Subject: MHI's Responses to US-APWR DCD RAI No.38

Responses to Request for Additional Information No.38 Revision 1

US-APWR Design Certification

SRP SECTION: 15.00.03 – Design Basis Accidents Radiological
Consequence Analyses for Advanced Light Water
Reactors

Figure 15.00.03-17-1 Site Plan with Release and Intake Locations

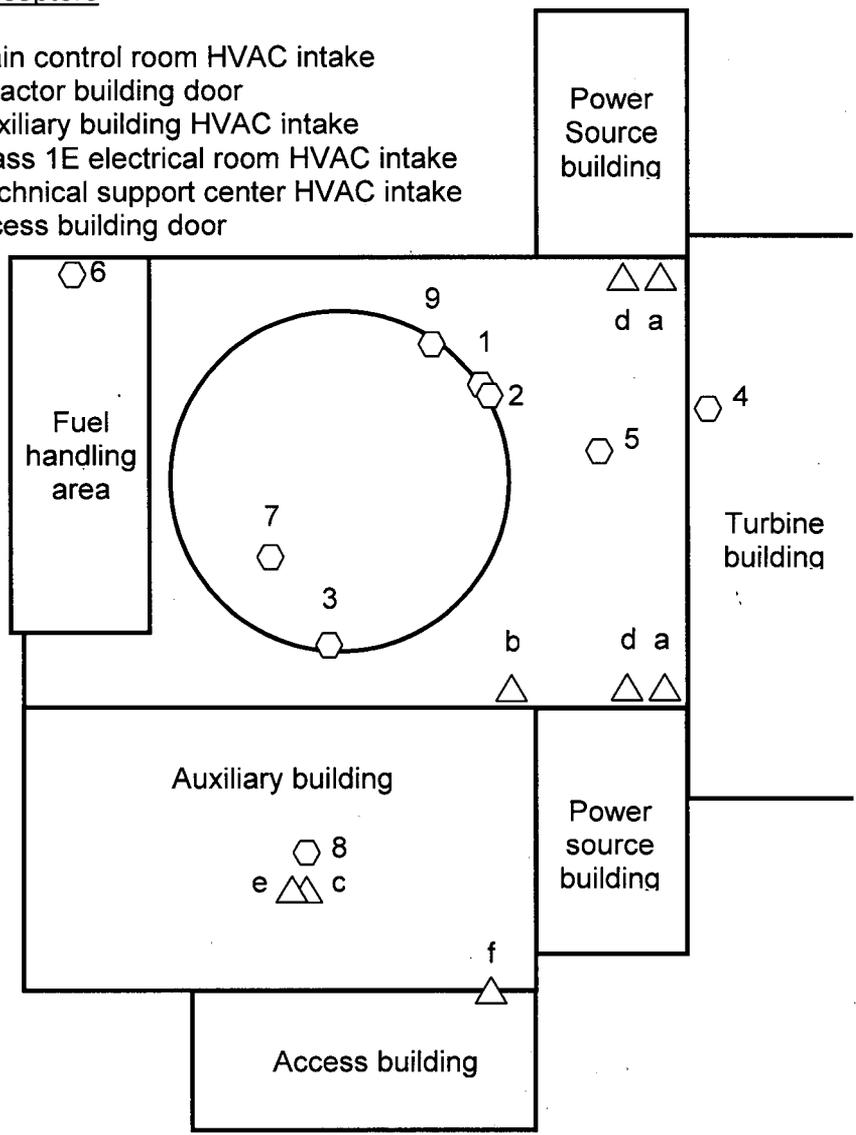
DCD 15.6.5.5.1.3 states that the technical support center (TSC) dose consequences are represented by the control room dose consequences and there are some qualitative statements about the relationship of the TSC model to the control room model. Please provide the details of the TSC dose consequence model, sufficient for the NRC staff to determine independently if the control room dose consequence model is bounding for the TSC. Include information on the TSC intake and unfiltered inleakage receptor locations sufficient for the NRC staff to determine independently that the TSC atmospheric dispersion factors are bounded by the control room atmospheric dispersion factors for all DBAs.

The technical support center (TSC) dose calculation models are the same as the main control room (MCR) dose calculation models. The relationship among the potential release points, the TSC air intake points, and inleak points are shown in Figure 15.00.03-17-1, which is identical to DCD Figure 15A-1, except for the addition of the TSC intake and inleak receptors.

The χ/Q values shown for the RCS sample line are used for the failure of small lines carrying primary coolant outside containment shown in Table 15.00.03-17-5. Based on the layout provided in Figure 15.00.03-17-1, the reactor coolant is assumed to spill in the auxiliary building, be discharged to the atmosphere from the plant vent, and be transferred to the TSC via the TSC HVAC system. However, the TSC dose consequence evaluation uses χ/Q values based on the conservative assumption that radioactive materials leaked in the auxiliary building are transferred directly to the TSC through the access building door. Therefore, the failure of small lines carrying primary coolant outside containment dose consequence assessment uses χ/Q values for TSC intake and inleak at the access building door.

Figure 15.00.03-18-1 Modeling method for evaluation of direct dose from reactor containment at the time of the accident

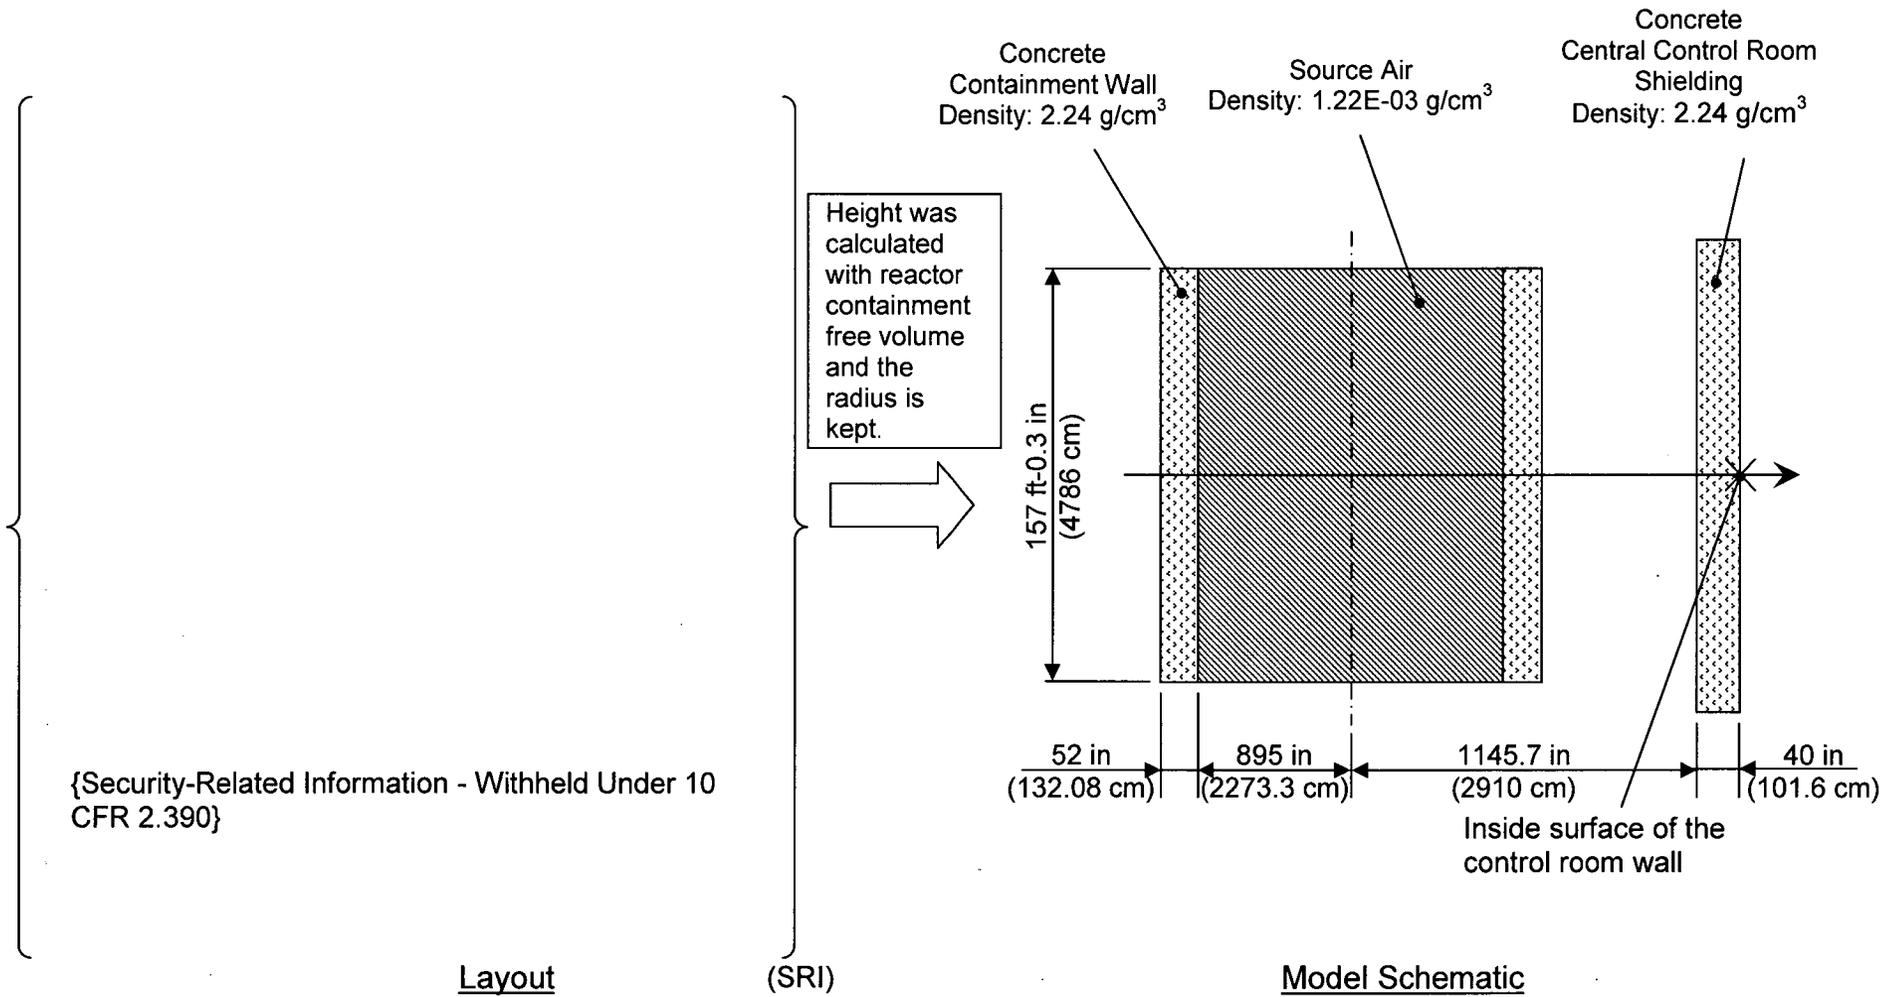
Provide the control room direct dose calculations and justify the assumptions and inputs. Indicate the receptor location for the operator used in the control room direct dose model.

Figure 15.00.03-18-1 provides a schematic description of the containment source model. The source term is modeled as a cylinder whose radius and height are determined from the radius and free volume of the reactor containment. The operator's position is on the inside surface of the control room wall.
